Addendum 86: Regulation No. 87

Revision 2 – Corrigendum 1

UNIFORM PROVISIONS CONCERNING THE APPROVAL OF DAYTIME RUNNING LAMPS FOR POWER-DRIVEN VEHICLES

Figure 1"

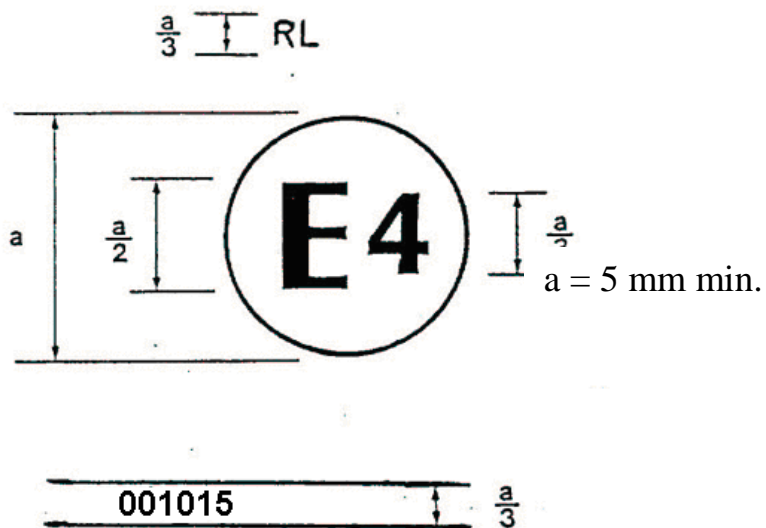
Figure 1, amend to read:
